Docket No. 034942-000245
(formerly 110619CFB.US)

In the Drawings

The attached replacement and annotated sheet(s) of drawings include changes to FIG. 1 and FIG. 2 as follows:

Serial No.: 09/885,811

Fig. 1

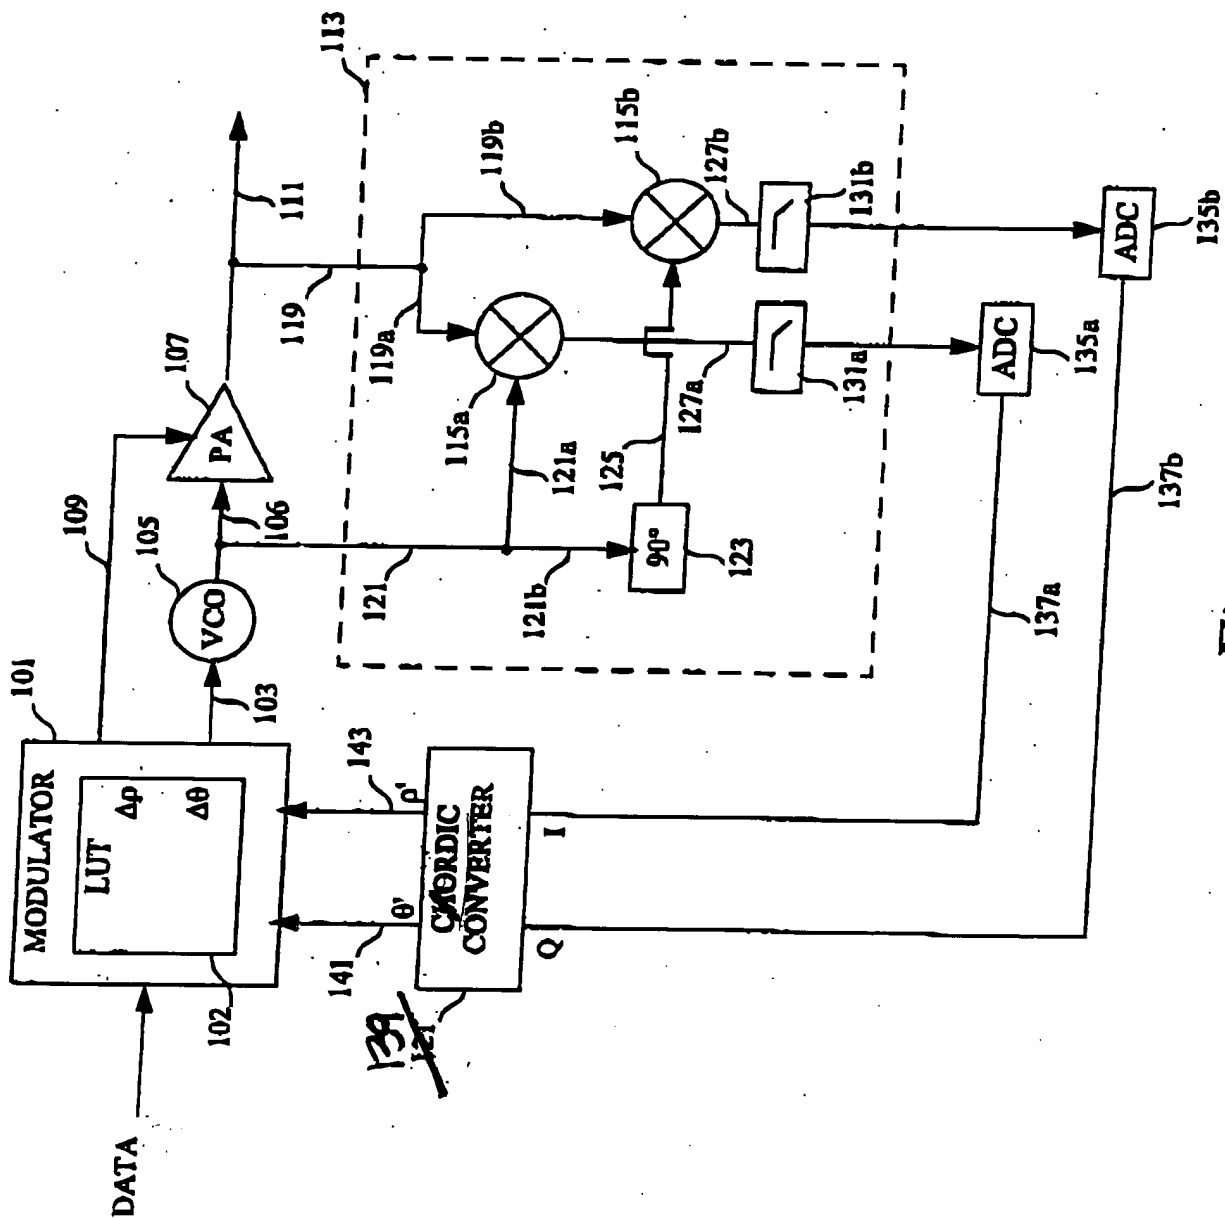
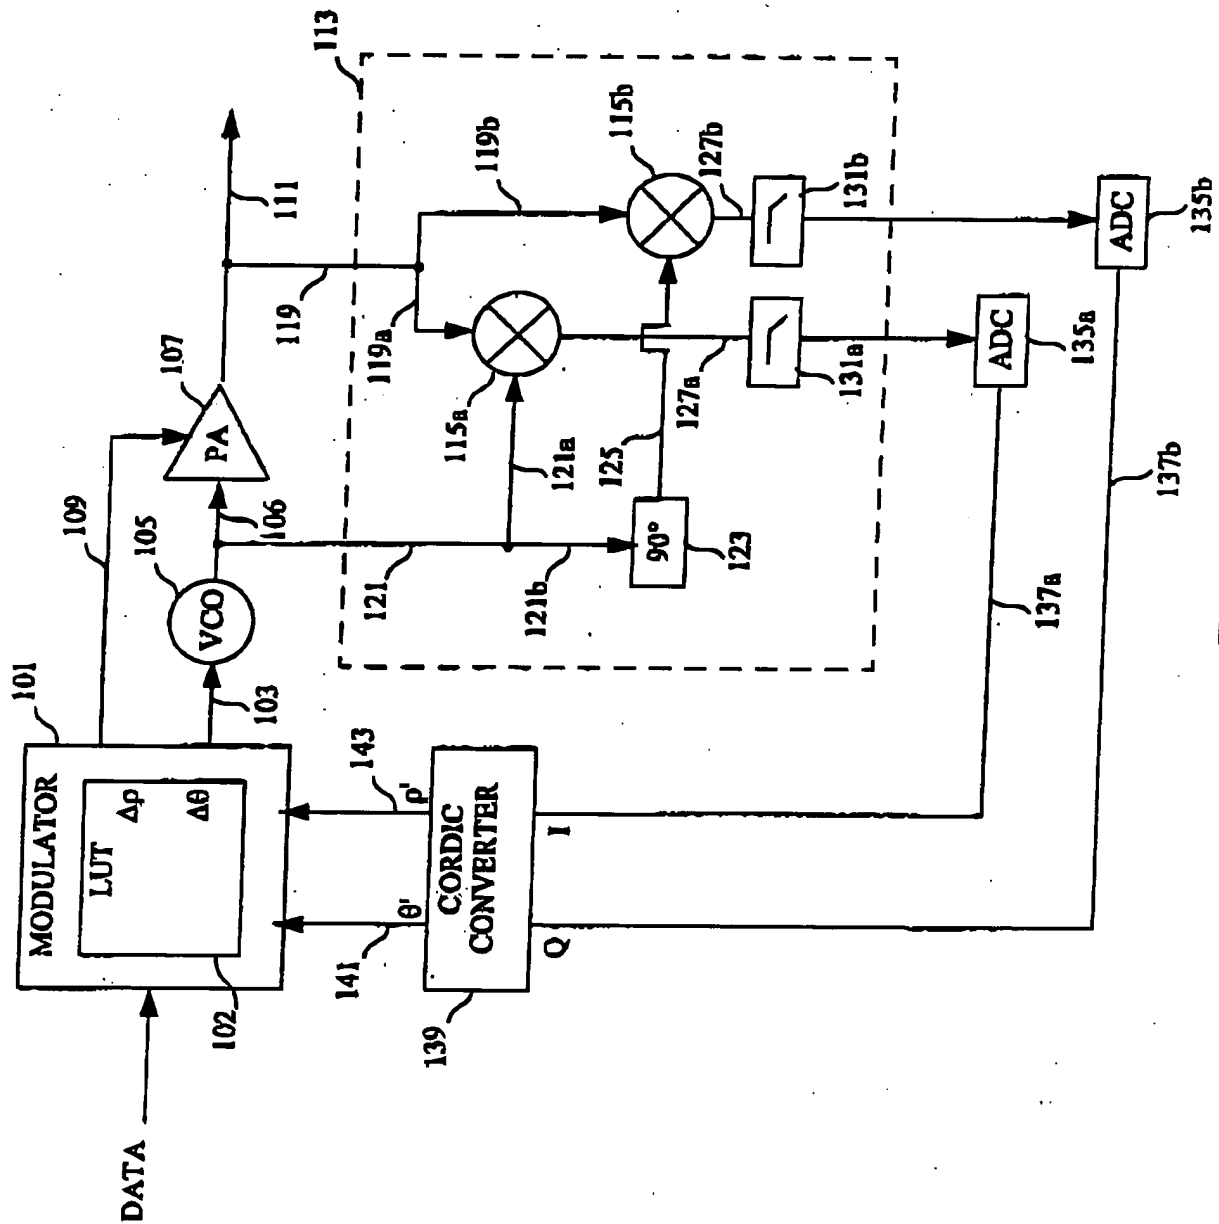
FIG. 1 has been amended such that box 121 has been relabeled 139 for consistency with the specification, and the descriptive legend has been changed from "chordic converter" to "cordic converter" to thereby correct the misspelling.

Fig. 2

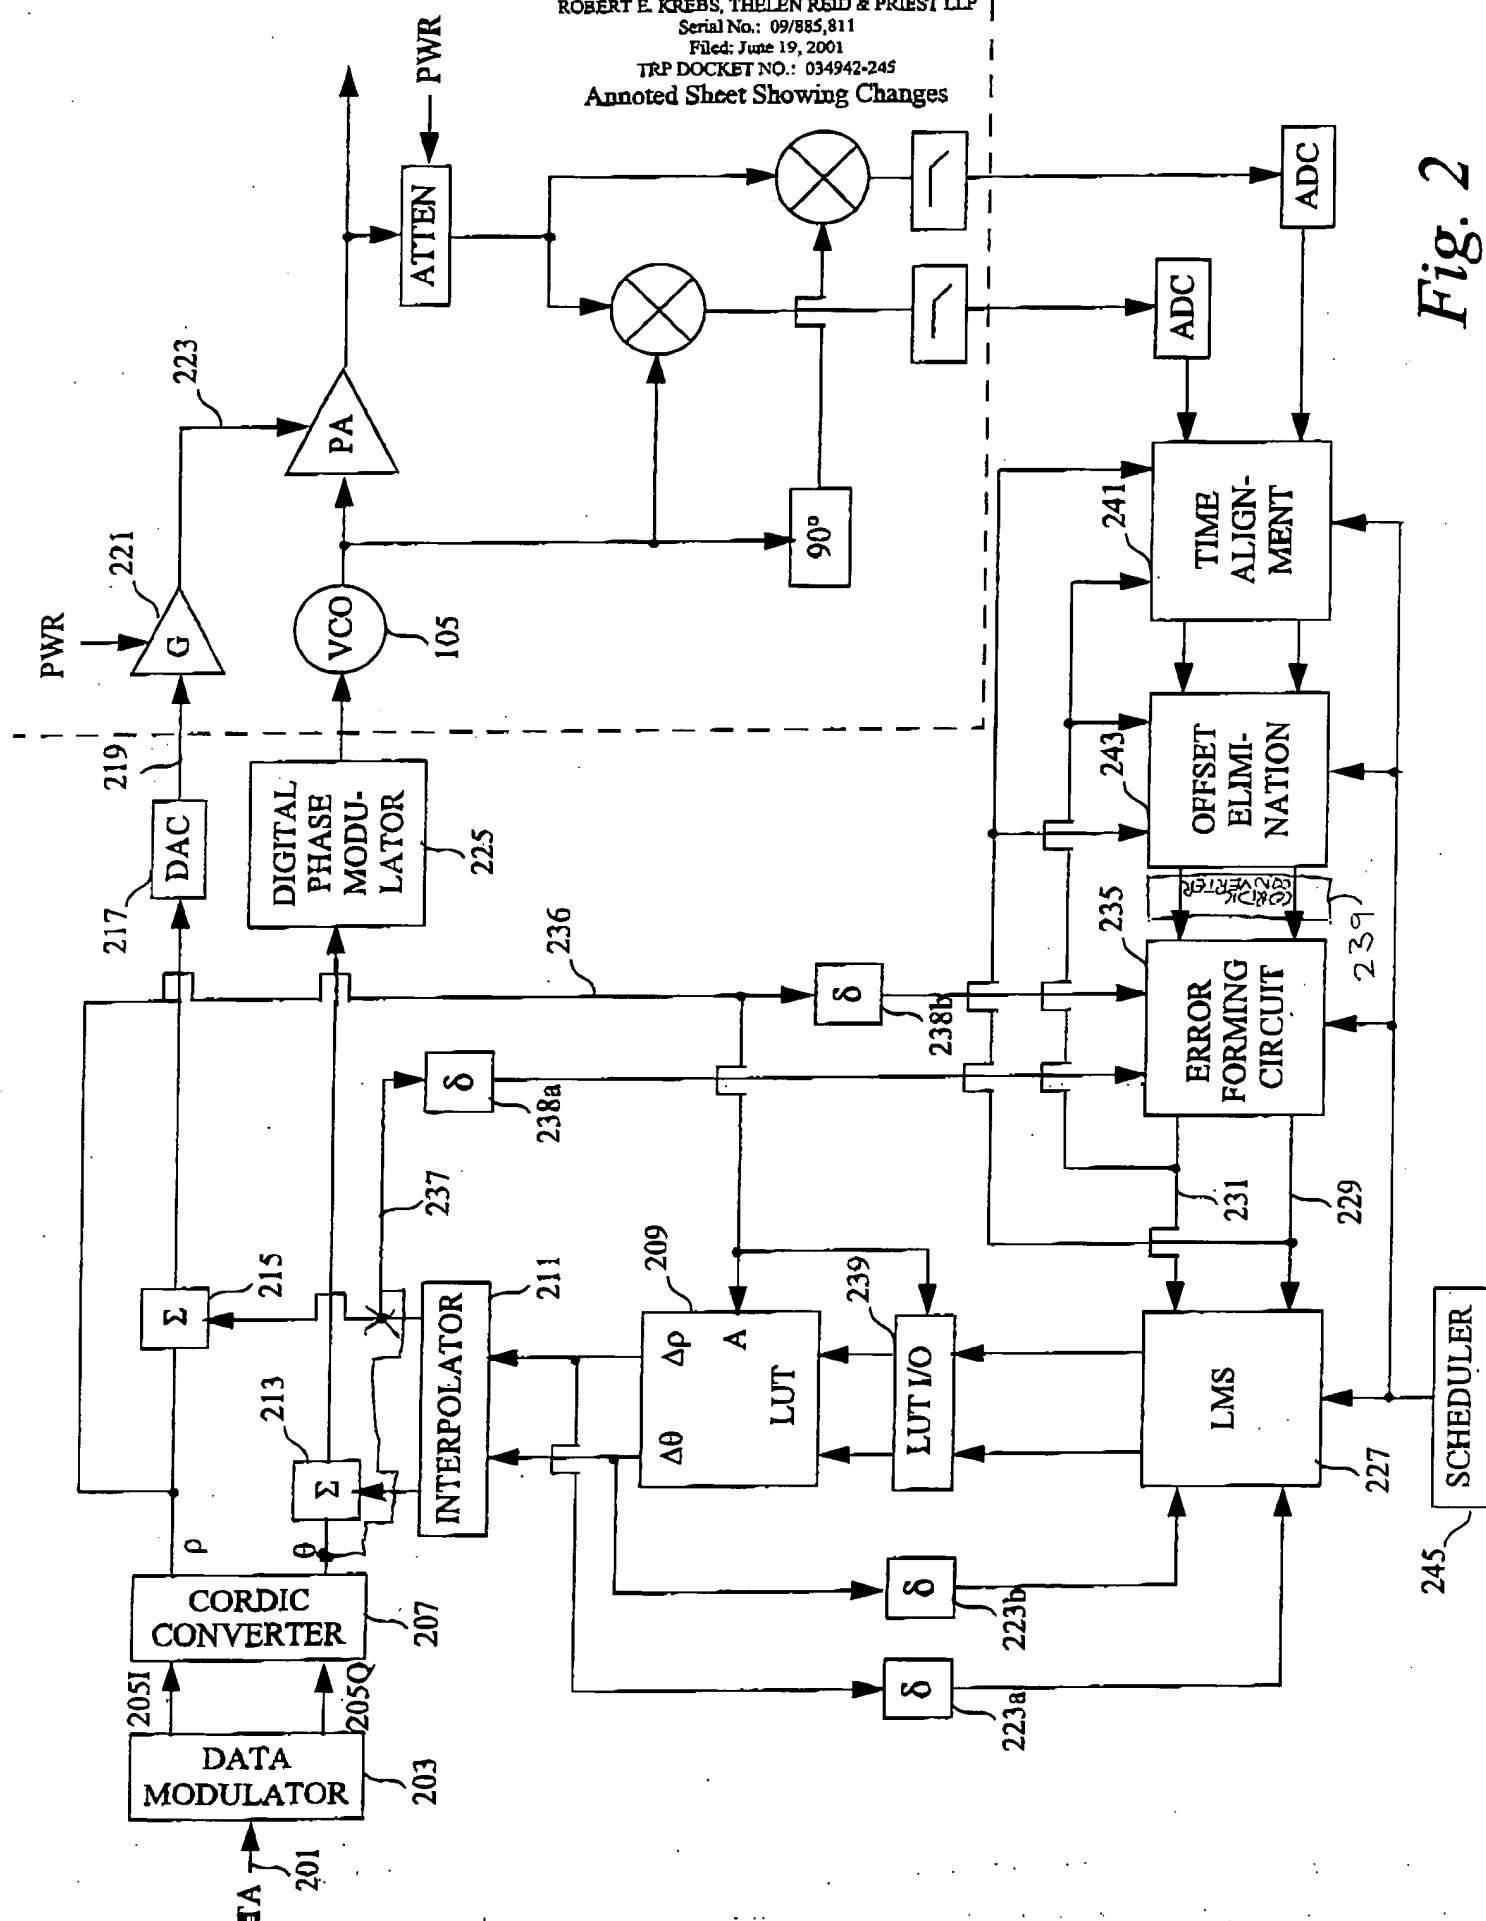
FIG. 2 has been amended to re-route the connection 237 to the delay element 238, and to insert cordic converter 139 of FIG. 1 in its proper place for consistency with FIG. 1 and the remainder of the description.
